CITY OF DELAWARE
HISTORIC PRESERVATION COMMISSION
AGENDA

OCTOBER 25, 2017

2017-2427: A request by M and J Union LLC for a Certificate of Appropriateness for a patio extension at Roop Brothers Bar at 17 North Union Street which is zoned B-2 (Central Business District) and located in the Transitional Sub-district of the Downtown Historic District Overlay.

2016-2532: A request by 12 West LLC for a Certificate of Appropriateness for a scope change for the new building located at 14 West William Street which is zoned B-2 (Central Business District) and located in the Transitional Sub-District of the Downtown Historic District Overlay.

Proposed Patio Union Street Elevation and North Parking Area Elevation

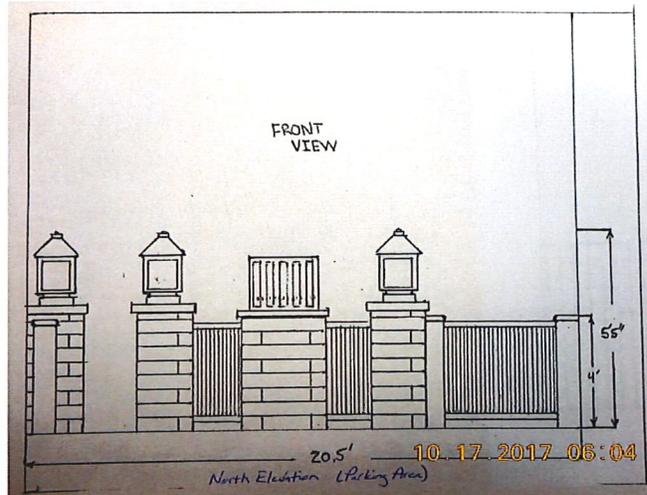
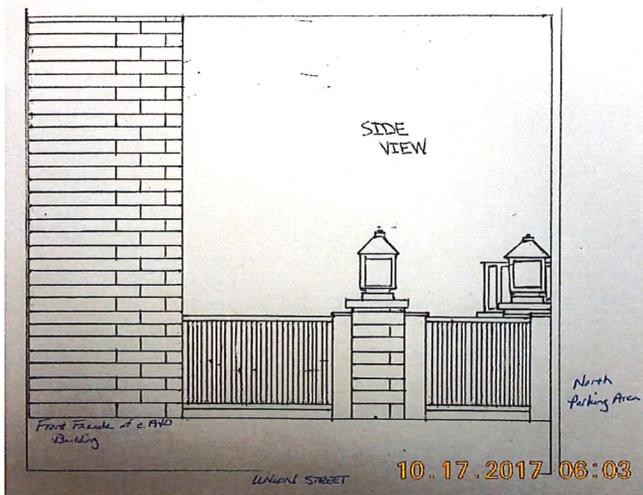
The Owner wishes to extend the existing concrete patio pad and fence farther east to the edge of the building to create a 14 foot by 20-1/2 foot (287 square foot) patio area on the Owner's private property. (Staff wishes to point out there will be no infringement on any public right-of-way.)

City Staff is supportive of the proposed renovation plan as presented. The Owner has been cooperative and sensitive to the suggestions and guidance as provided by Staff and the Architectural Standards of the Historic District. The commitment to a successful place of business and the surrounding neighborhood and businesses is clearly exhibited through the forethought of discussing the project with the Sarah Moore assisted living facility, which is directly across Union Street from this site.

- 2) A clear passage must be maintained between the existing gate opening at covered patio and new gate opening at northeast corner of patio extension.

- 3) The project is completed per the plans presented. Any significant revisions to the approved plans shall need, at a minimum, administrative approval by the HPC or another HPC meeting, depending on the magnitude of any revisions.

TOP
VIEW

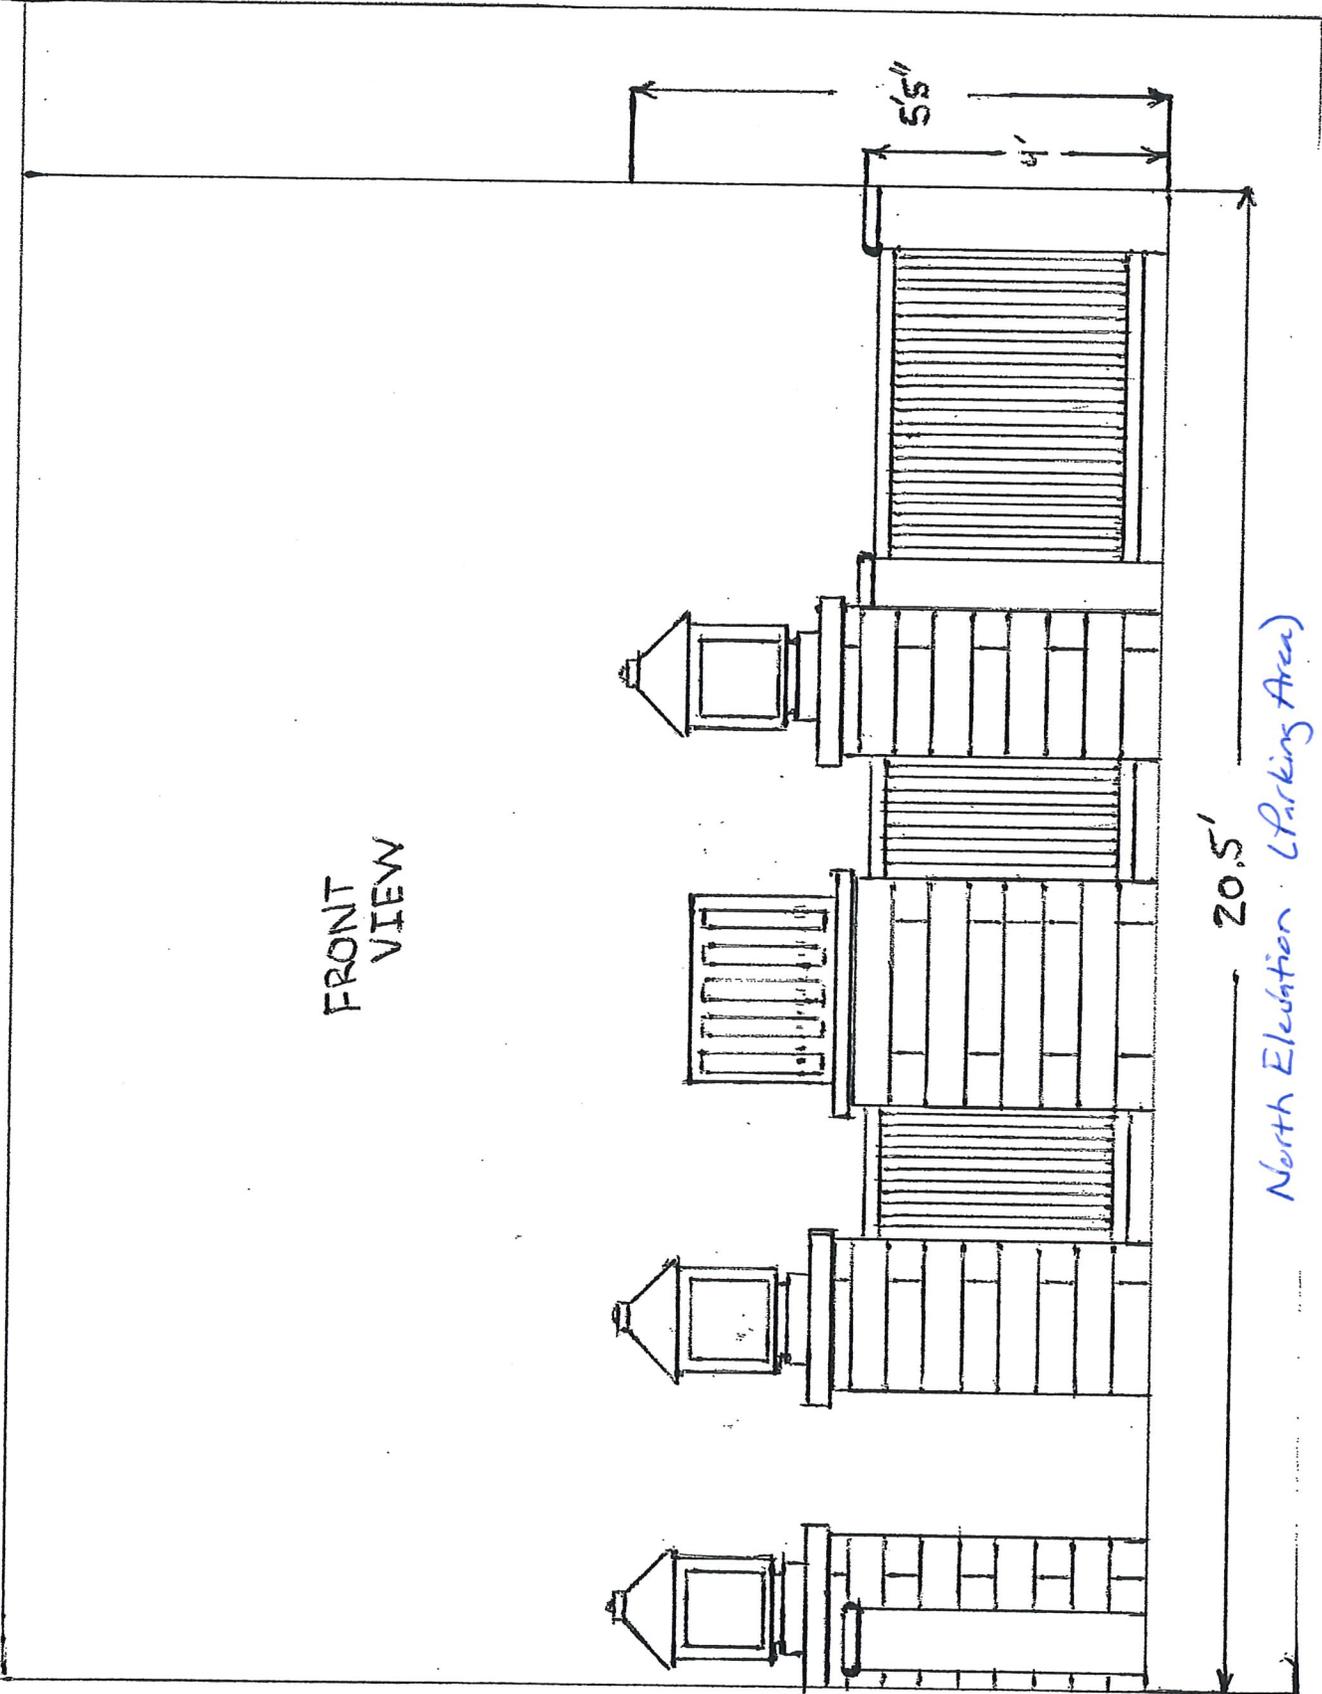
PROPOSED PATIO EXTENSION
14' x 20.5' (287sf)

Gate
Opening to
North Parking
Area

**Proposed Site Plan and Interior Layout
(north is toward the bottom of this page)**

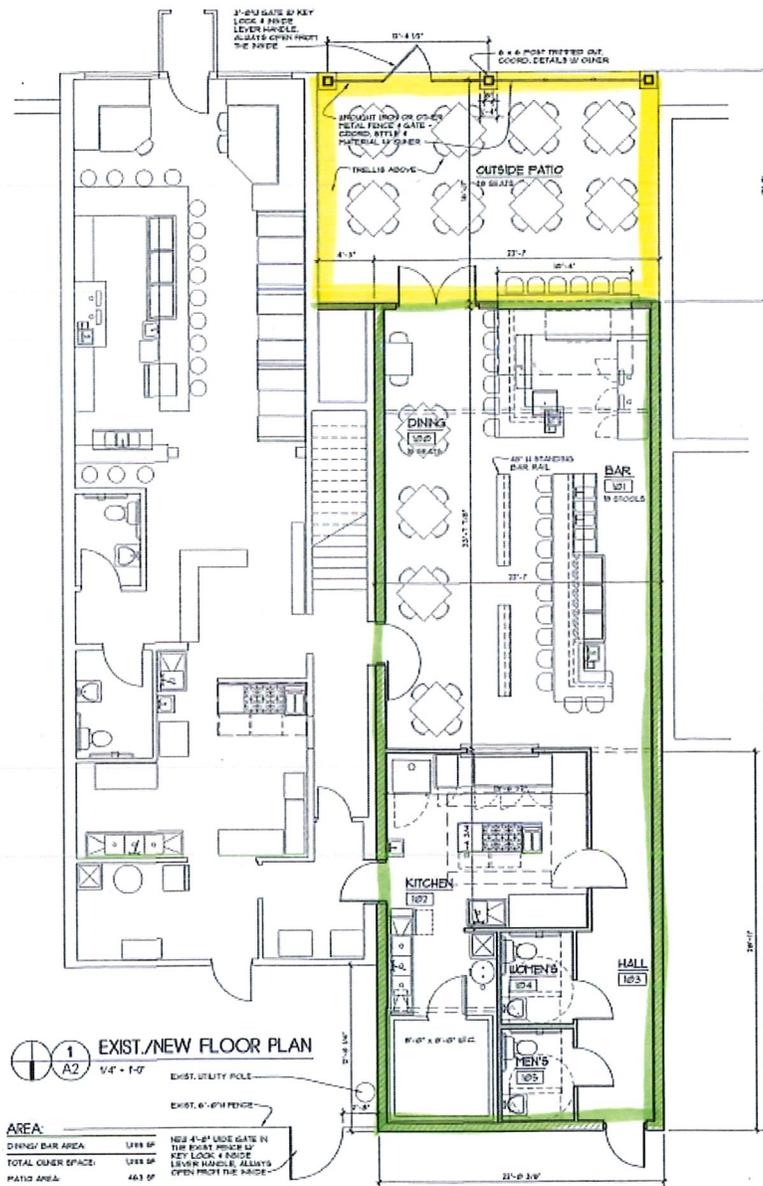
The Applicant is proposing a slightly larger building and smaller patio area than proposed by the previous owner. The new one story approximate 1,392 square foot (22 ft x 63.3 ft) building, with a 442 square foot (17 ft x 26 ft) patio, will create the appearance of a continuous streetwall along West William Street as desired by HPC. The building will still sit on its own parcel and will be constructed independently from the adjacent buildings while abutting the buildings to its east and west. The building to the east at 12 West William Street is the 12 WEST Café, which is owned by the Applicant. The building to the west at 18-20 West William Street is The Collective Hair Salon, which is owned by another party. The proposed building would give a nod to the appearance of the former West End Grill, as well as Bargdill Groceries store (circa late 1800s).

The site plan reveals the building would be setback almost 17 feet from the property line with an outdoor patio in the area between the sidewalk and building and extending to the buildings to the east and west. (The plan previously approved had a building setback of 23 feet from the property line with an outdoor patio in the area between the sidewalk and building and extending to the buildings to the east and west.) A 3 foot high black steel spindled fence will be supported by three (3) three feet high graphite-colored splitface textured block columns with a beveled stone column cap to separate the patio from the sidewalk. (Staff would suggest using a different brick face in the color and texture of the historic brick of the surrounding buildings such as face brick, quik-brik – structural brick, and cultured limestone.) An entrance gate would be located on eastern portion of the fence. (Staff would suggest that this entrance gate not be utilized as entrance gates for sidewalk patios are not utilized, generally, in the downtown. This has been acceptable by the State for liquor control approval purposes in the past. The issues Staff would note with the proposed gate configuration are that it would swing out over the City’s property requiring permission and licensure for such, the gate blocks emergency services for immediate access to the site, and each patron would have to open the gate to reach the front door of the building. Alternatively, the gate should be made to swing both inside and outside and a City licensure would be required to be obtained to retain this element.) Patio flooring materials are still under discussion and should be discussed by the Commission to ensure clarity of requirements in this regard.

- 1) Any significant revisions to the approved plan layout would need, at a minimum, administrative approval by the HPC or another appearance before the HPC by the Applicant, depending on the magnitude of any future revisions.

- 2) The Applicant shall assess and address building classification, storm water drainage, parking, and refuse pick-up issues with adjoining property owners/business and construct said building and site according to the State Building Code, City codes, and Historic District Architectural Standards.

Proposed South (Front) Elevation – With Patio Fence

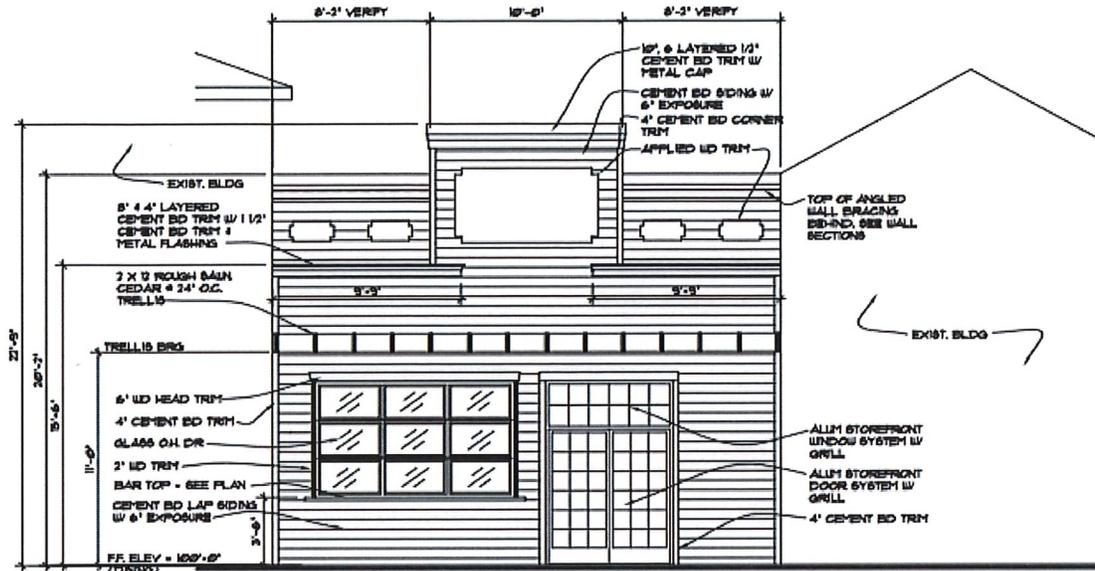
Trimmed out 6’x6’ exterior grade wood columns would extend 8 feet from the three foot column caps to support a 2’ x 12’ rough sawn cedar trellis (at 24” on center) with cedar top trim extending over the entire outdoor patio.

The proposed color scheme is gray-tones in a combination of lighter grays SW7067 Cityscape/SW9163 Tin Lizzie and darker gray/browns SW7625 Mount Etna/SW7675 Sealskin. The specific color combination is still to be determined. The approximate 23 foot high building would be constructed of gray-toned cement lap siding with 6 inch exposure. (Staff would like to recommend a 3-1/2” or 4” exposure which may be more conducive to the time period of this building site.) A double front 27 light aluminum exterior storefront entry door with a 12-light transom will be the main entry on the east side of building front to align with the entrance gate of the patio fence. (Staff would like to recommend the entry doors be wood or wood metal-clad and glazed with at least 50% and not more than 75% glass in area according to the Architectural Standards.)

- 3) The Applicant shall adhere to Historic District Architectural Standards for new construction of this building and site (i.e., entrance doors, trim covering, paint and material colors, light fixture style, etc.). Such items are to be incorporated into final construction drawings and discussed with and approved by Staff and HPC Chairman prior to construction.

- 5) The fence gate proposed shall either be eliminated or shall require separate review and consideration by the City in order to allow it to swing over the City right-of-way. The Applicant is required to approach the State of Ohio liquor control agency to attempt to have this removed to facilitate safety force access to the front of the structure.
